1 Products affected

Product hierarchy no. *			Part no.	SBU	Type / Description	Customer part no.
SBU PG	PGU	Type				
02	007	038	0000002296	4796.0000	Connector	4796 Appliance Inlet
02	007	038	0000002365	4310.0008	Connector	0106 Appliance Inlet
02	007	038	0000002365	4310.0009	Connector	0106 Appliance Inlet

2 Type of change

4796`#\$\$`*					0118.2127	
creation date	created by	release date	released by	notification no.	revision	page
2012-09-13	sha	2012-09-14	sha	23911		1 of 2

3 Detailed description of change

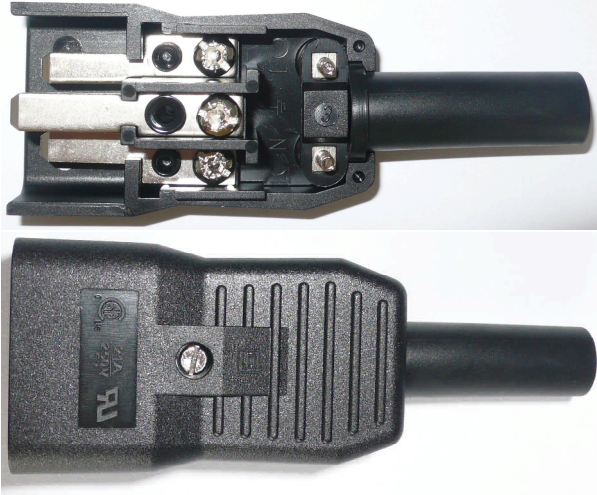
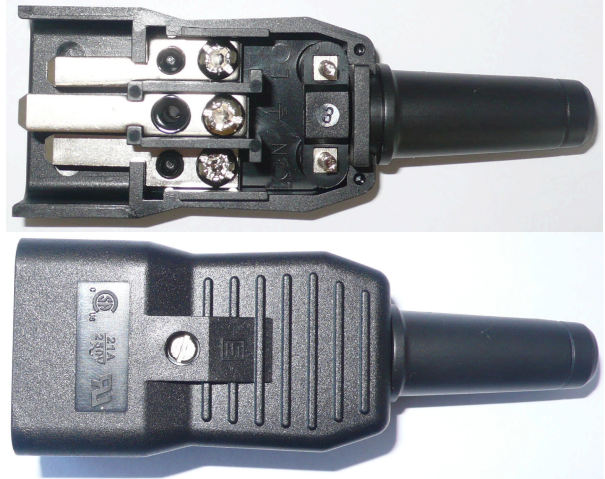
A new tool has been made.
Modification of the Approval marks.
With the production of the new tool the Tension relief has changed too.

The flange of the Tension relief was round, what caused an insufficient hold of the Tension relief.

NEW the flange of the Tension relief is square, what improves the holding of the Tension relief.

According to 60320-1 sect. 22 (Cords and their connection) the Tension relief with the round flange could fall out at the test. As there have been made new tools for the moulding parts the holding of the Tension relief got improved with a square nut. The Tension relief has new a square flange.

With the production of the new tool the Approval marks got updated according to UL/ CSA/ IEC/ CCC.
